Appl. No. 10/616,058
Amdt. dated July 15, 2005
Reply to Office Action dated May 17, 2005

AMENDMENTS TO THE DRAWINGS

Annotated Sheet Showing Drawing Changes

FIG. 1

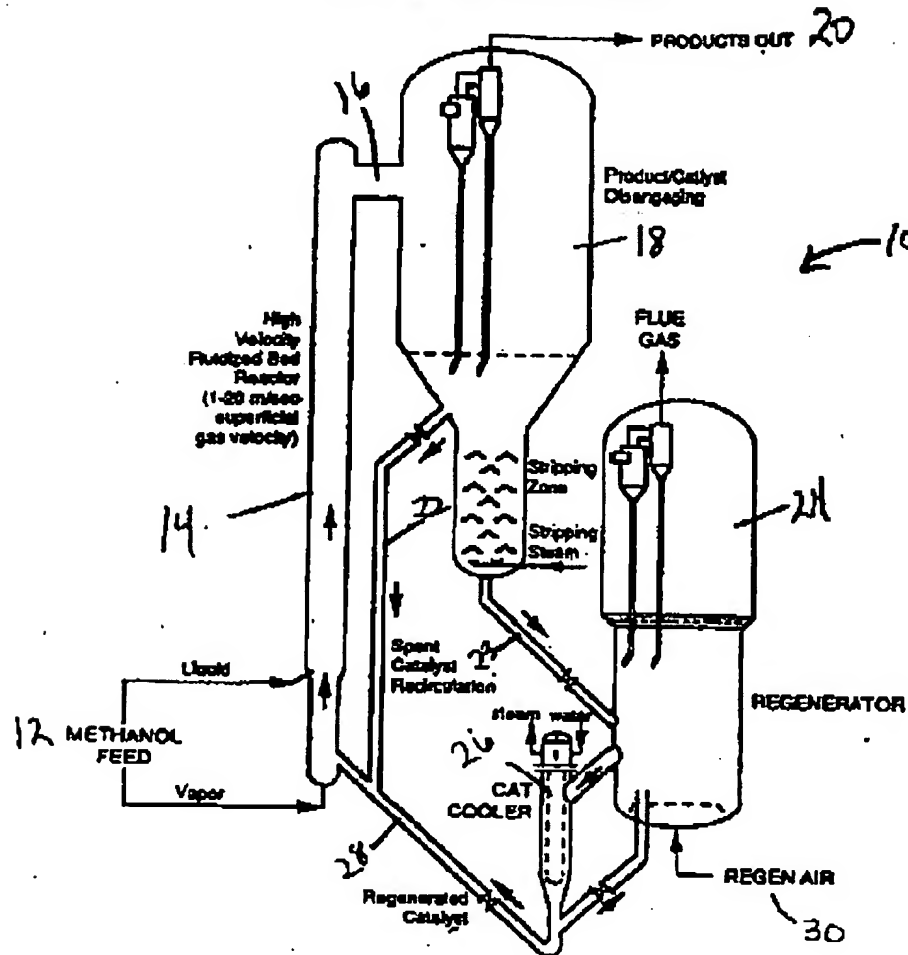
The drawing was objected to for not including a reference sign regarding "oxygen 30." The attached Annotated Sheet Showing Drawing Changes is submitted in response, with the addition of element "30" shown in red ink. The title "Fig. 1" has also been added so as to correspond with the description in the specification at page 3, lines 11-12.

The attached Annotated Sheet Showing Drawing Changes is submitted in response to the objection to the drawings, with changes to the drawings shown in red ink. A replacement sheet will be submitted shortly to meet all formal drawing requirements.
